I spent some time reviewing the alarms for the EF-11 fan failures and this is what I found. You will notice the fan status to “on” follows the comand failure by at least 4 hours in every instance. Therefore, fails the immediate command to run.

Propeller Exhaust Fan Detail

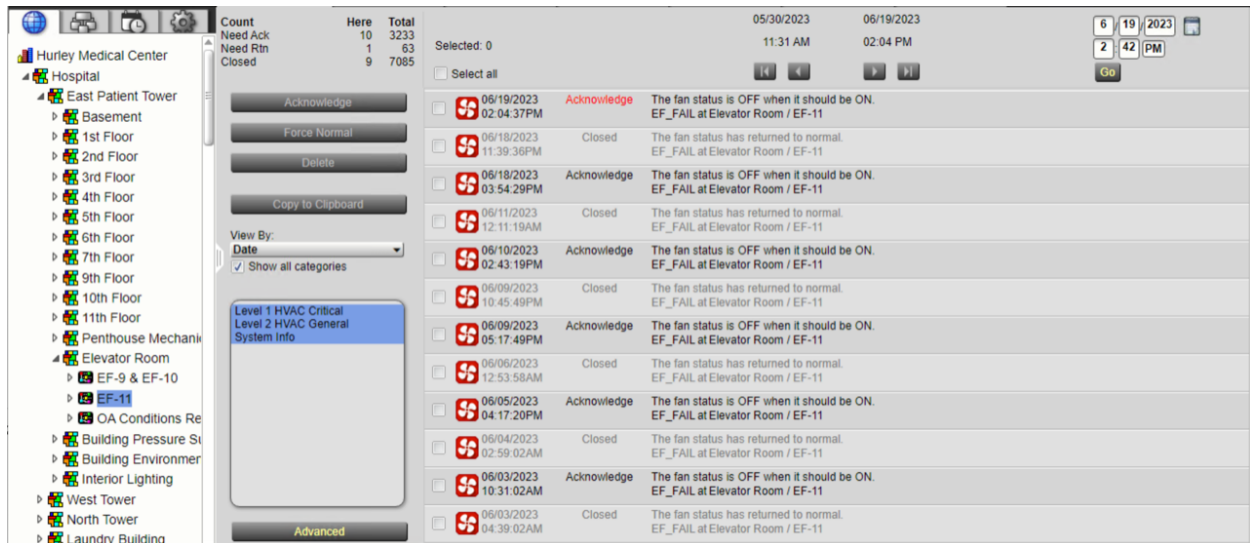
Alarms are being issued and recorded that appear to be in error and are non-synchronous to operation of the unit EF-11.

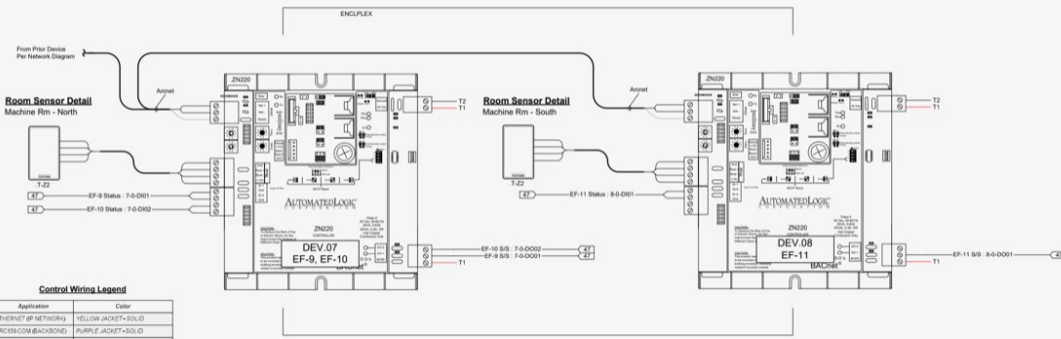
According to the as-built drawings supplied by your organization (see below). The controller is shown wired to a RIB relay (not found) at the fan unit and there is no integral damper actuator shown that opens the OA damper before fan operation either. No Sequence Of Operation (SOO) is described.

Examining the control panel I found one, not two controllers, operating both rooms with EF-9,10,&11. The fans are wired to existing IDEC “ice cube relays” in the old Honeywell panel and appear to have DO1 output connect to orange wire and DO2&3 (EF-9&10) with gray wired to the outputs and spliced to white wire at the relays (why?). There is a newly installed spring return Belimo actuator wired to open each exhaust fan damper and (I assume) the power to the fan is wired through the limit switch on the actuator, requiring "proof of open" before the fan starts. The as-built diagram in no way represents this.

Please have your technician review the programming and wiring and have the programs corrected. Also, correct the erroneous as-built document to the correct wiring and controller name and address.

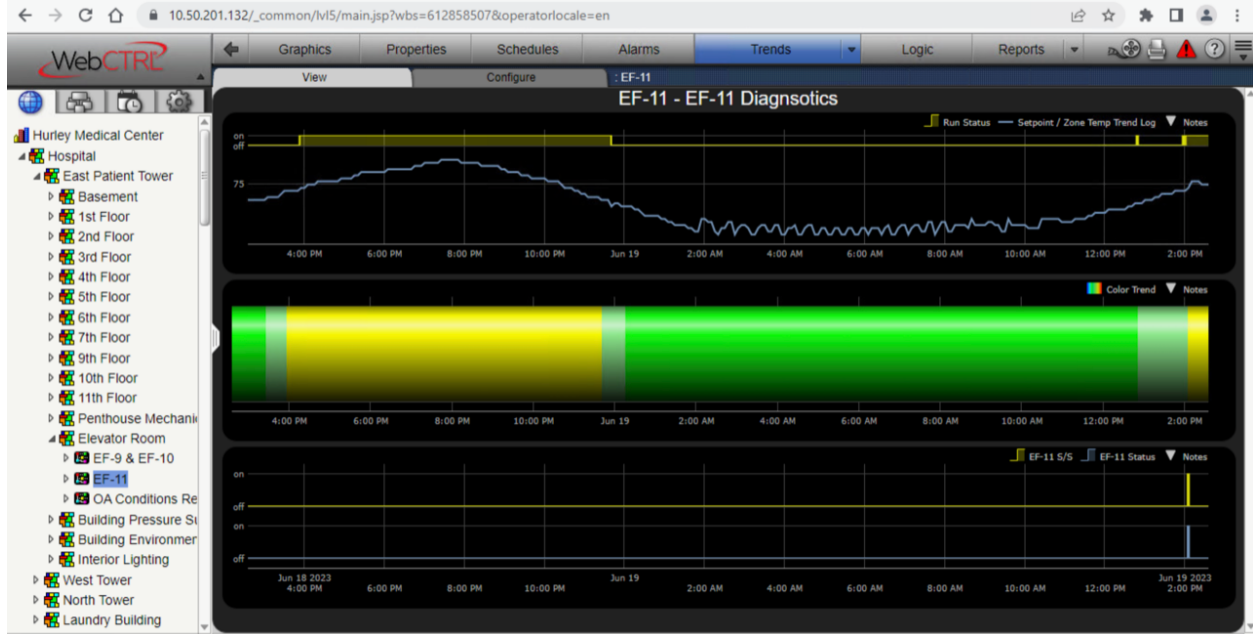
This trend **discloses the fan works fine and does not run and is not commanded on???**- and was only commanded on by me- the far right yellow and blue "blips".
